# CITY OF ALBUQUERQUE

**RE: La Vida Liena**  
**10501 Lagrima de Oro Road NE**  
**Conceptual Grading and Drainage Plan**  
**Engineer's Stamp Date: 04/22/19**  
**Hydrology File: F21D028**

Based upon the information provided in your submittal received 04/22/2019, the Conceptual Grading Plan and Drainage Report **is not** approved for action by the DRB for Site Plan for Building Permit. The following comments need to be addressed for approval of the above referenced project:

## CONCEPTUAL DRAINAGE PLAN EXISTING CONDITIONS

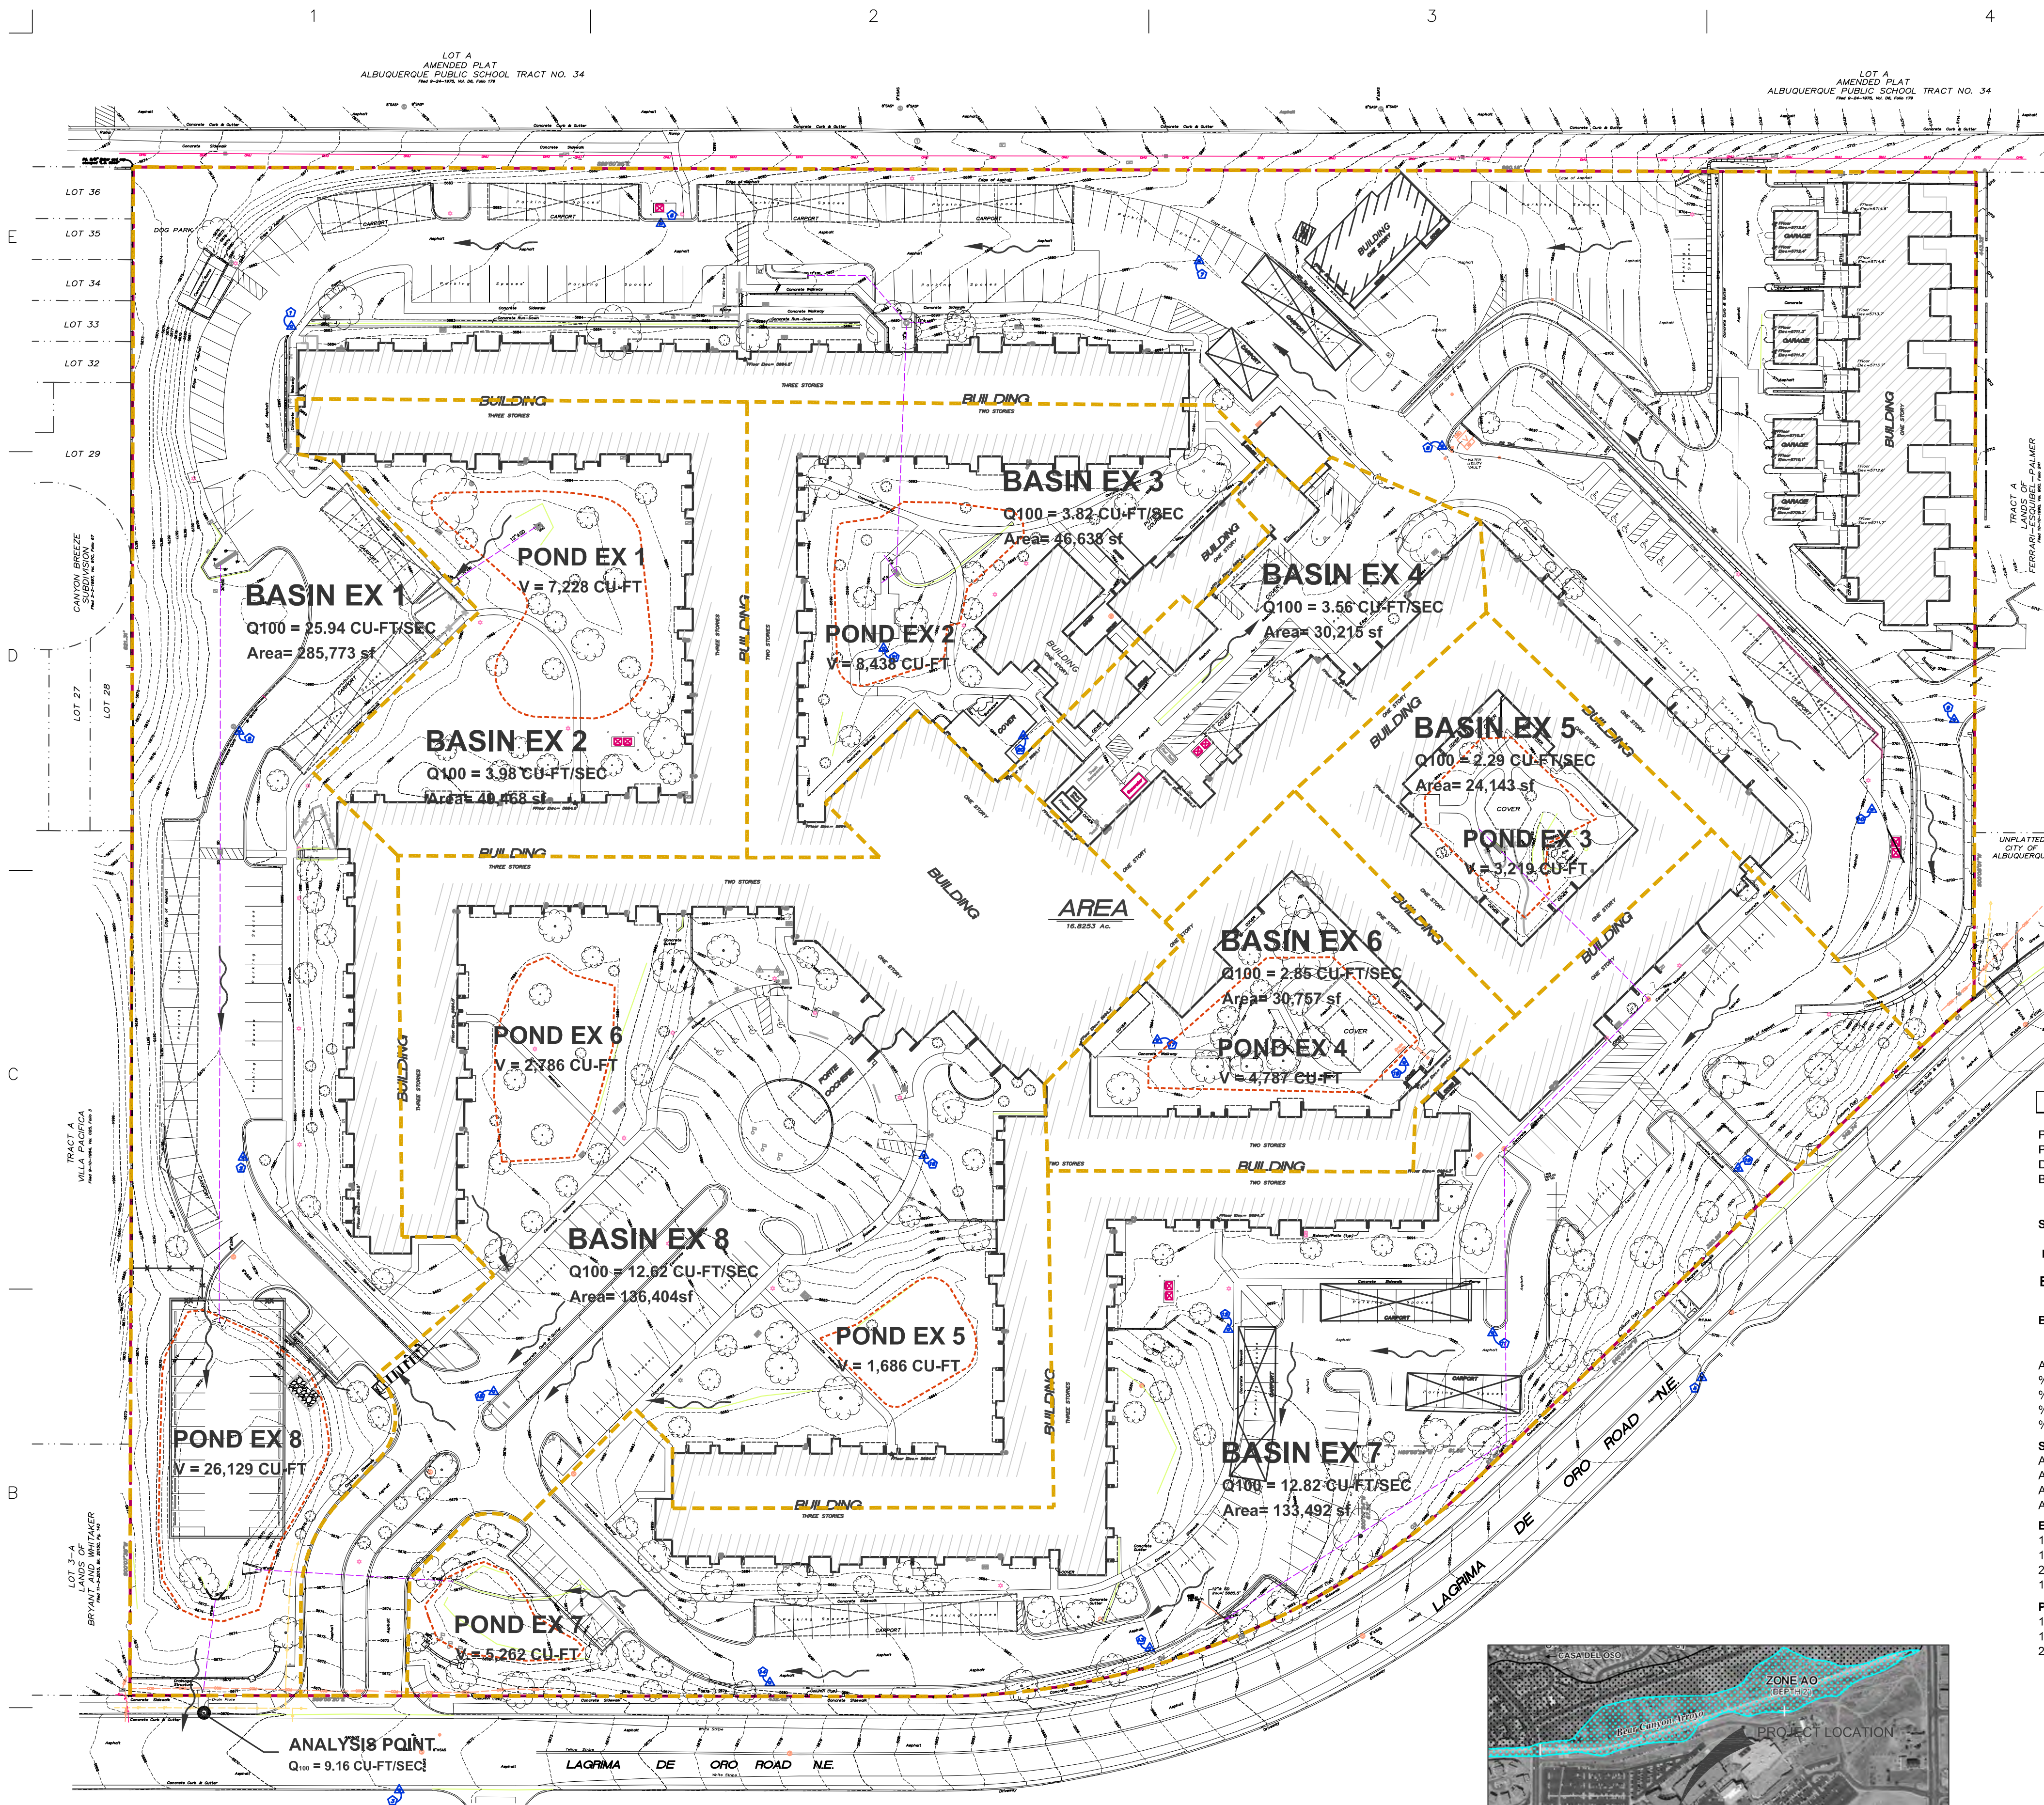
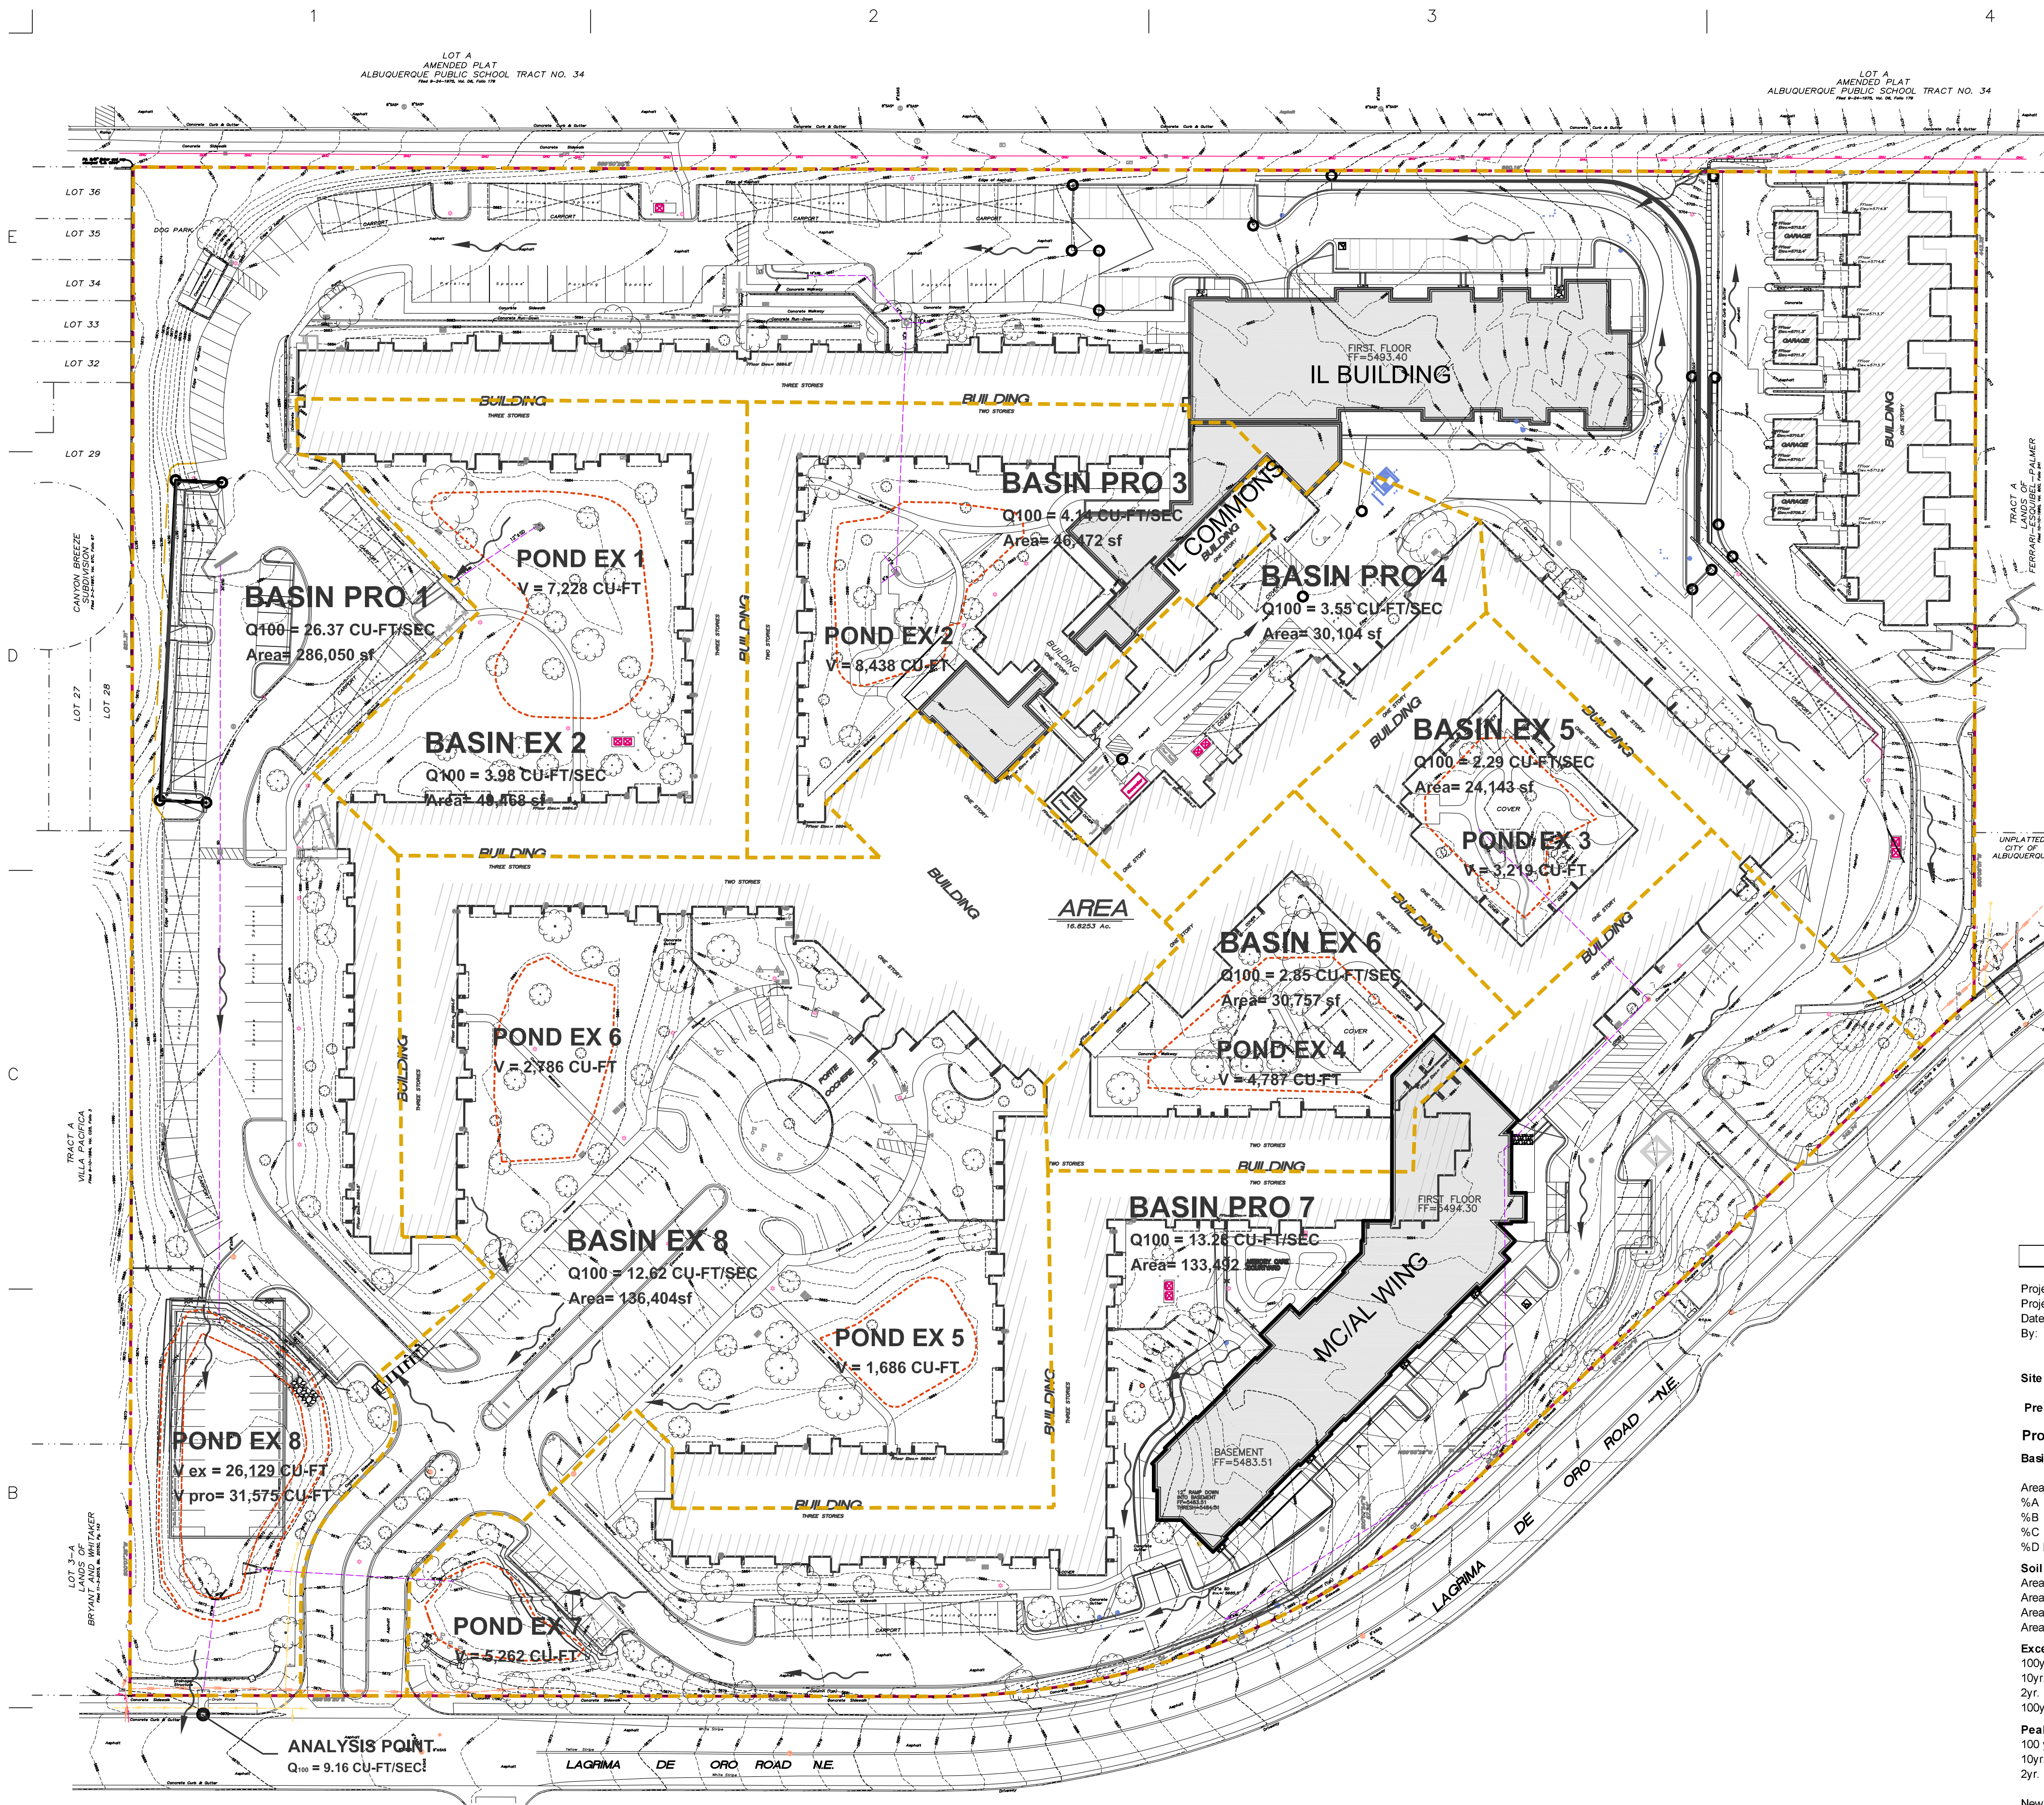
1. Sheet CD-1. Please remove the proposed parking structure over existing pond 8.
2. Sheet CD-1. Please add the information about the existing turn blocks in the wall for the emergency overflow for existing pond 8. See photo below.

3. Sheet CD-1. Please add a statement stating that you have physically verified the existing outfall structure in both the pond and within the ROW of Lagrima de Oro Road and have found it functioning as designed.
